MC68341

ADDENDUM TO MC68341 Integrated Processor User's Manual

April 19, 1995

Figure 3-12. M68300 Write Cycle timing

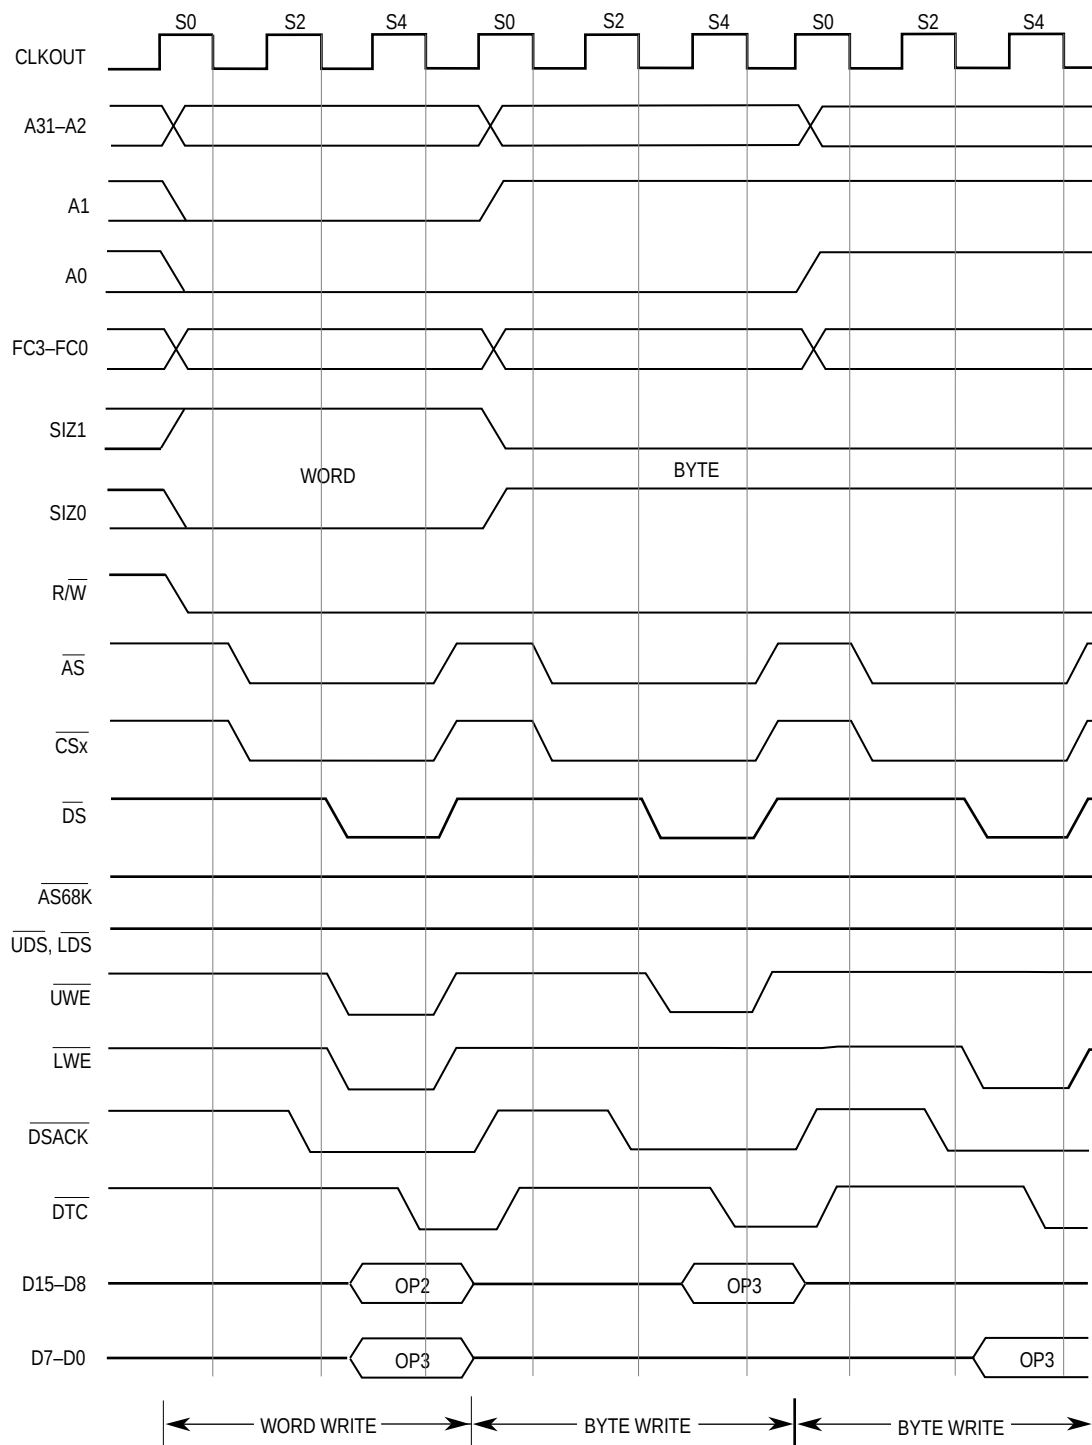
On page 3-25, the M68300 write cycle timing diagram (Figure 3-12) shows incorrect timing for $\overline{DS}$, $\overline{UWE}$, and $\overline{LWE}$. On page 3-28, the M68000 write cycle timing diagram (Figure 3-14) shows incorrect timing for $\overline{AS68K}$, $\overline{CSx}$, $\overline{UDS/LDS}$, and $\overline{UWE/LWE}$. Replace these figures with the following corrected figures.

Figure 11-2. Sample Crystal Circuit

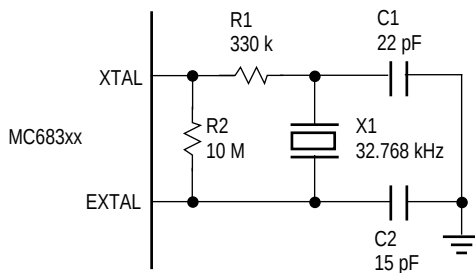
On page 11-2, Figure 11-2, a 10M resistor can be substituted for the 20M R2 bias resistor as shown below.

Figure 11-14. Circuit For Interfacing 8-Bit Device to 16-Bit Memory in Single-Address DMA Mode

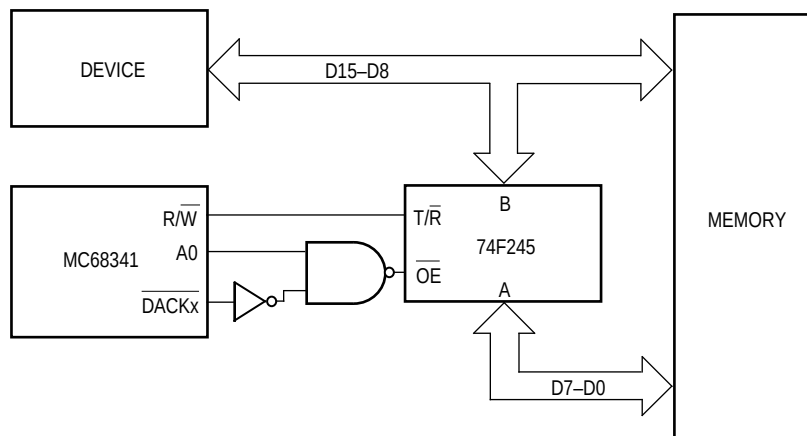
On page 11-10, the logic driving $\overline{OE}$ on the 74F245 in Figure 11-14 should be corrected as shown below. Although not detailed, the byte enables for the memory block should be controlled during reads to prevent contention between the upper and lower bytes of the data bus when D7-D0 is muxed to the upper data byte.

80. Page 9-19,

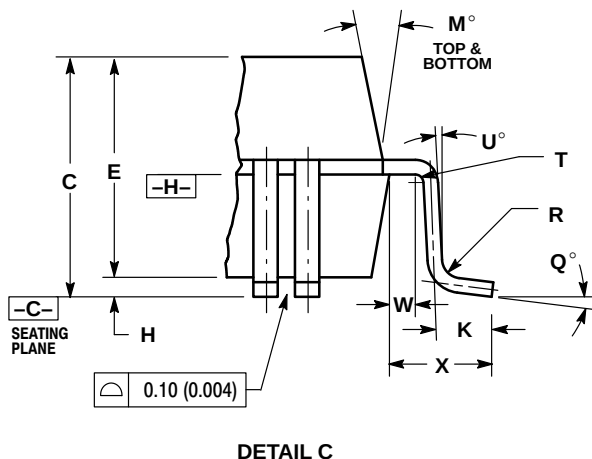
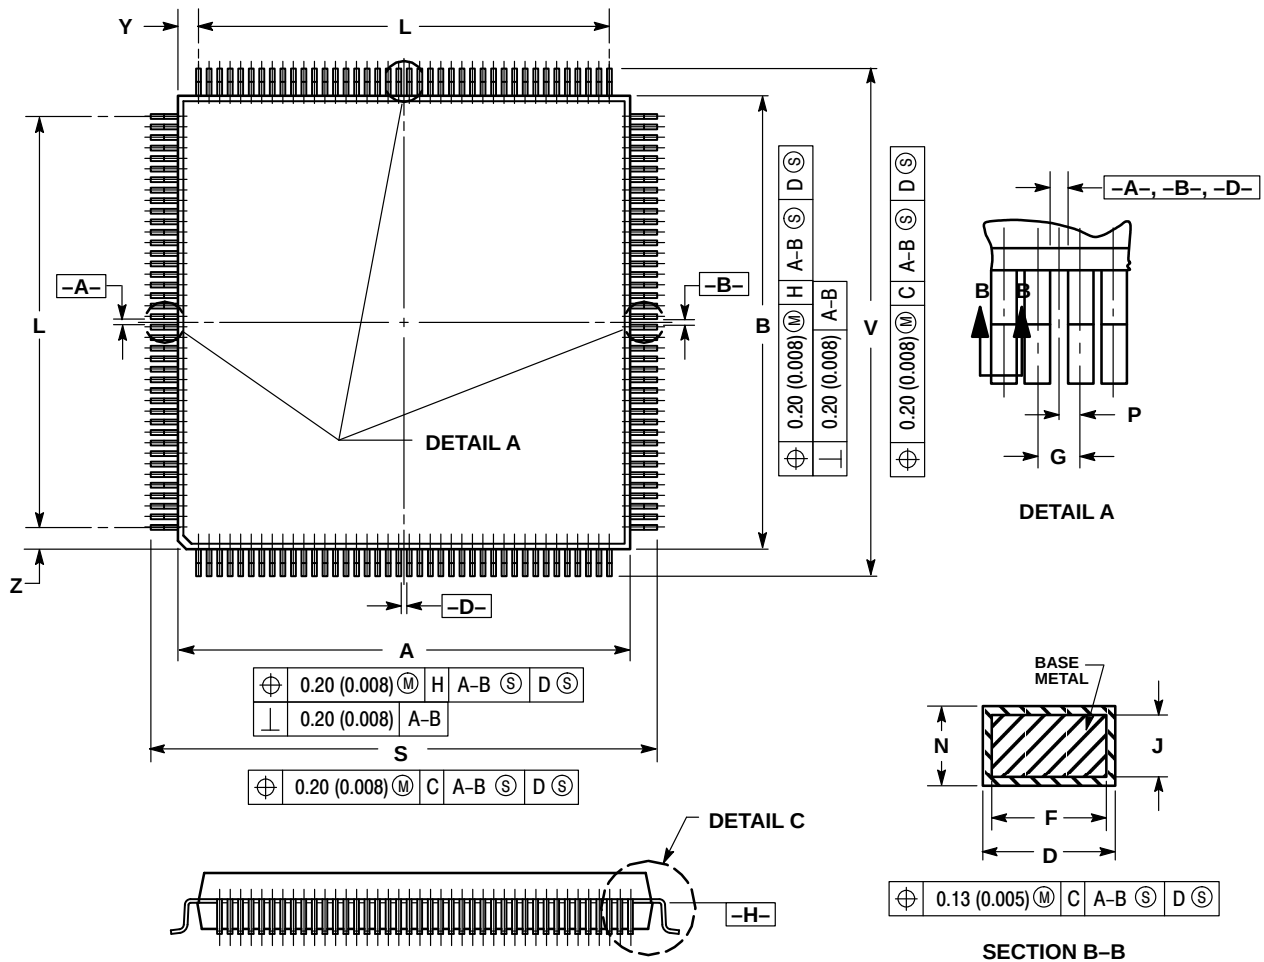
The timing diagrams reference as Figures 9-24 — 9-27 should be changes to 12-22–12-25.
